**Bureau of Environmental Health**

RECEIPT DATE: 8/2/18 **ONSITE SEWAGE DISPOSAL SYSTEM**P 563970APPROVAL DATE: 9/17/18 SEC **PERMIT: CONSTRUCTION**

PROPERTY ADDRESS: 1025 Thunderbird DriveSUBDIVISION: Fairlane FarmsLOT: 31 TAX ID: _____CONTRACTOR: South Carroll BackhoeEMAIL: scbackhoe@comcast.comCONTRACTOR ADDRESS: 4410 Salem Bottom Road, Westminster, MD 21157PHONE: 410-596-3618PROPERTY OWNER: NV Homes

SEPTIC SYSTEM
INSTALLATION SITE PLAN
LOT 31
1025 THUNDERBIRD DRIVE
FAIRLANE FARMS
PHASE TWO

VICINITY MAP
SCALE: 1" = 1200'

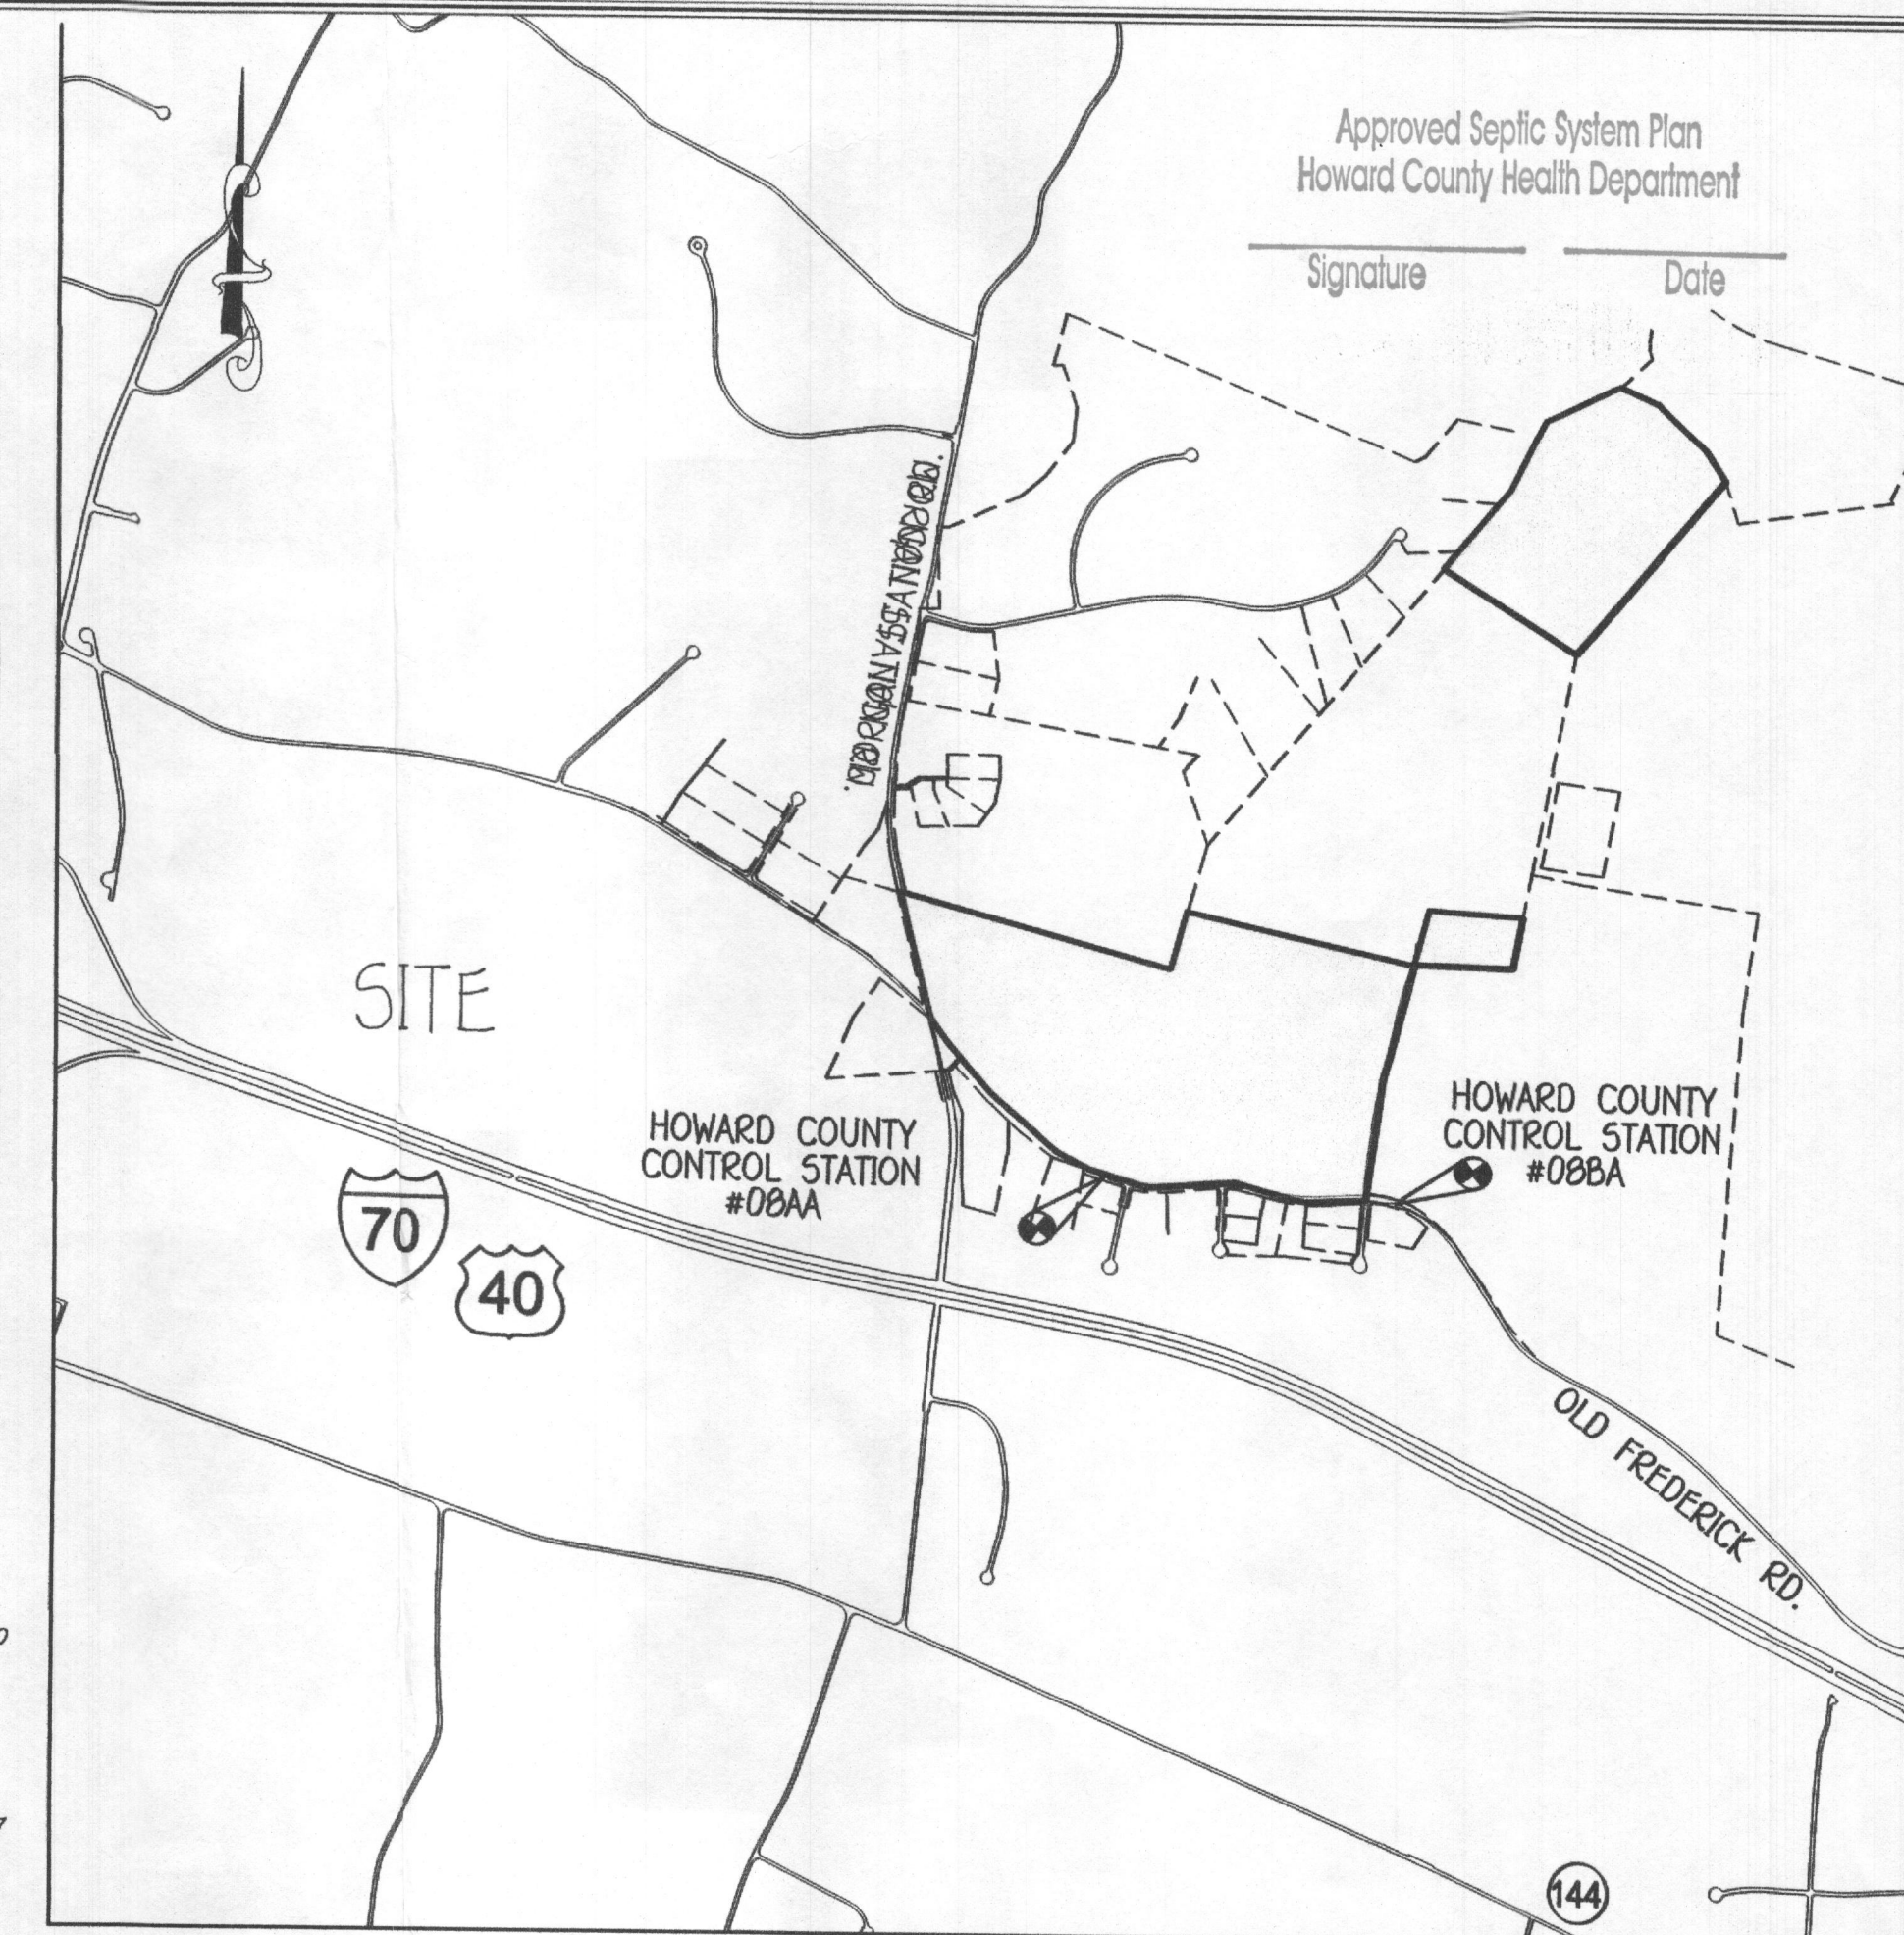
So if I'm understanding you correctly, the initial system will be at the bottom (lowest elevation) of the septic area, and the trench sizing will use the spec's for the 2nd replacement system (since that pertains to the lowest part of the septic area), correct?

Lot 31 is one of those lots that will work as a 1st floor gravity sewer system (a ejector for the basement sewer) if the initial septic trench starts as shown on the attached drawing. To force us to place the initial trench up higher will force the need for a whole house pump system and that is a big negative for the homebuyer of course. We easily fit 3 systems in the SDA with this layout, and hope the Health Dept. agrees that this will be acceptable. The initial trench lengths are 3 @ 43.8 ft. The 2nd system trench lengths are 3 @ 49.6 ft. And the 3rd system trenches are 2 @ 60.1 ft. in length. Please let me know if this will be acceptable, so we can finalize the plan and let the builder and homebuyer know please.

Yes. Make sure the trench layout utilizes the lowest contour in an efficient manner. I would leave the tank where it is so that the homeowner can get gravity systems for as long as possible with future repairs.

Our general policy is to place the first system in the upper contour of the SDA. We occasionally make exceptions to this rule, but when we do, the policy is to install a system on the lowest contour, so that we maximize our area moving forward, just in the opposite direction. Starting the first system somewhere in the middle is not efficient use of the area. In this case, the lower part of the area does not have worse soils, so I'll allow a design showing the first system on the lowest contour and the future replacements can work their way up the hill.
